Staff Report

Re: PLNPCM2021-00169; PLNPCM2021-00168 – Bumper House Design Review & Planned Development

BUMPER HOUSE – DESIGN REVIEW & PLANNED DEVELOPMENT

FIGURE 2: Bumper House Site Plan

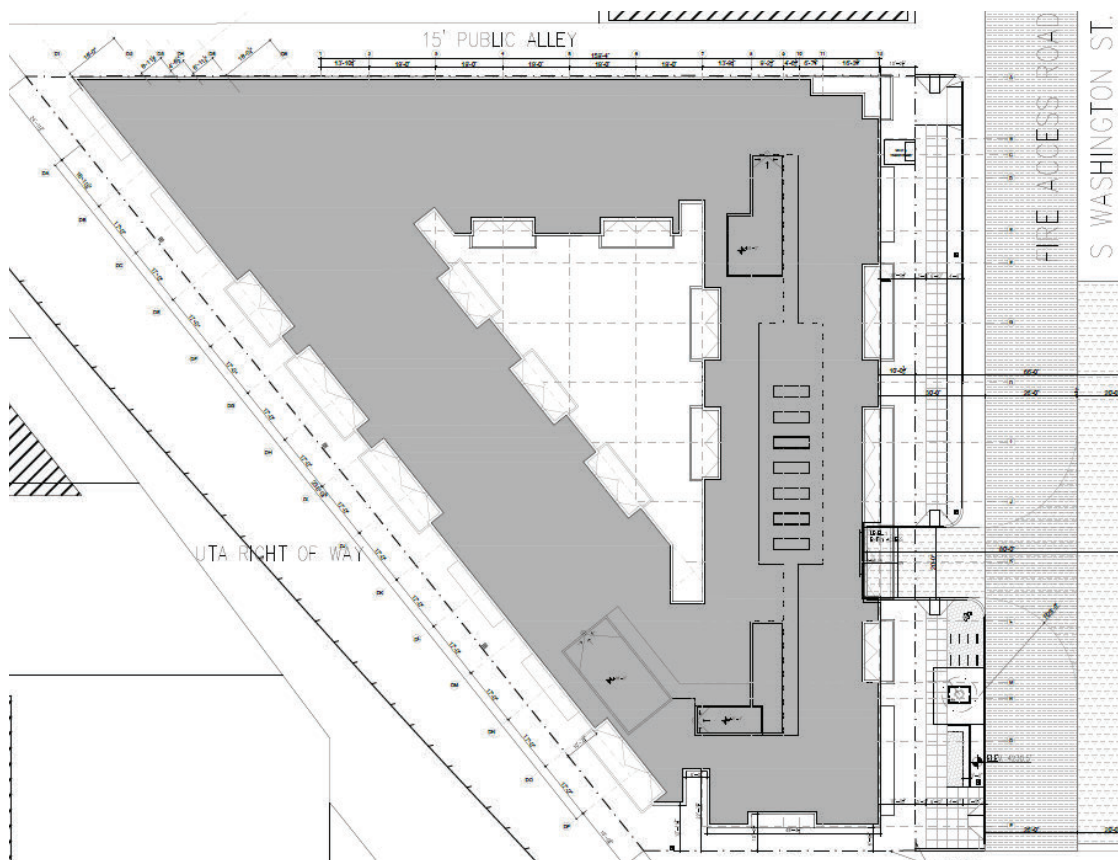
The Bumper House project requires a Planned Development as a request for a reduction in setbacks in the CG zone is proposed as well. The CG district requires a front yard setback of 10' and a 10' rear yard. There is no building setback requirement for an interior side yard. The project, as a way to enhance the building's appearance from the street and future rail line, will have balconies that project 4' from the building and into the required building setback areas. The structure of the building will be setback to the required standards on the interior side yard and the front and rear yards. The only projections into the setback area will be from the overhead balconies. The balconies placed on the east and west facades of the building do not project into the public right-of-way nor over any required walkway, the balconies will be located over landscaped area. The proposed balconies that project into the required rear and front yard setbacks are located on the third to seventh floors of the building.

The purpose of the front and rear setbacks in the CG district is to ensure landscaping in this district and to separate a more heavily commercial or business use from the public right-of-way. Generally heavier commercial districts do not provide landscaping unless it is through a required setback area with a percentage of that area required to be living landscape material. The intent of the setbacks in the CG district is being met as the proposed use is less impactful to the right-of-way than a heavy commercial use, the scale of the Bumper House building is appropriate to its proximity to the right-of-

1/A3.3

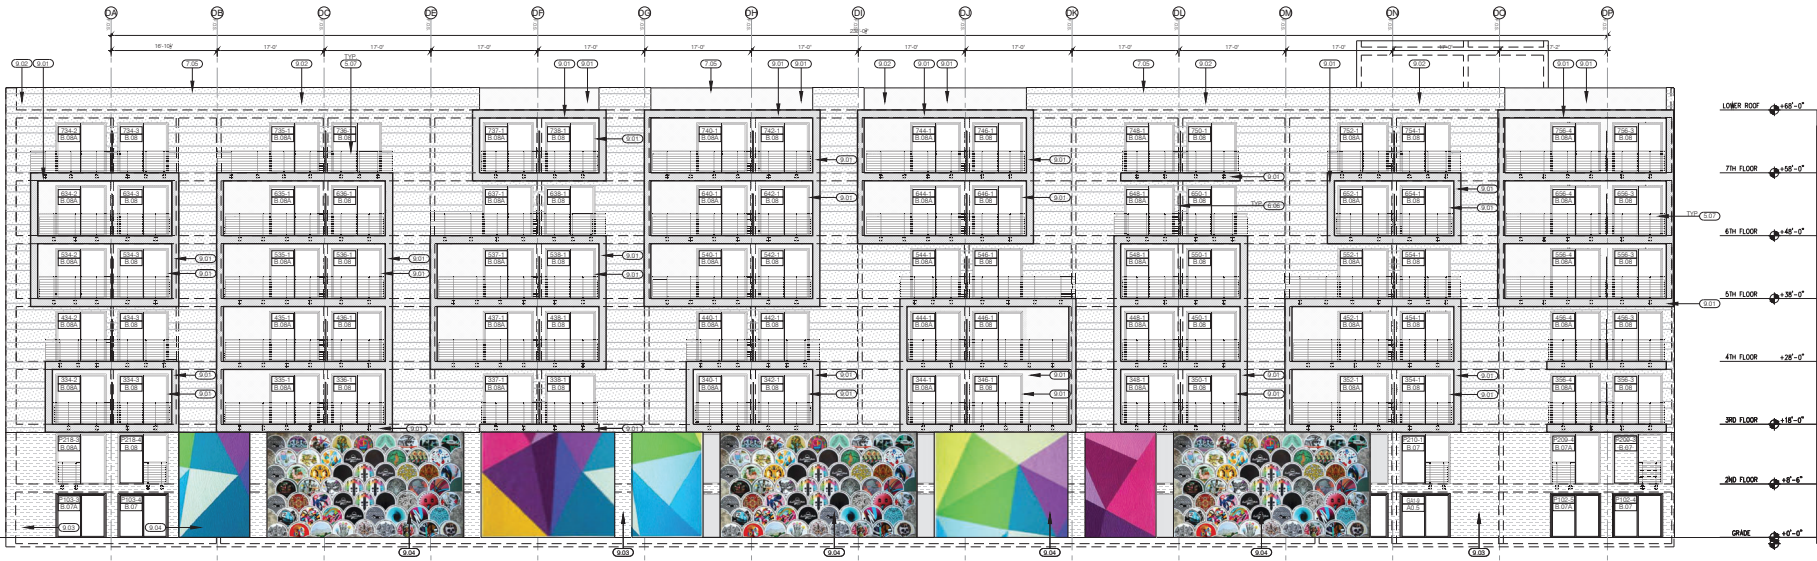
DO ANOTHER BIG, RECTANGULAR MURAL HERE SIMILAR TO WEST MURAL. BUT USE DIFFERENT PATTERNS
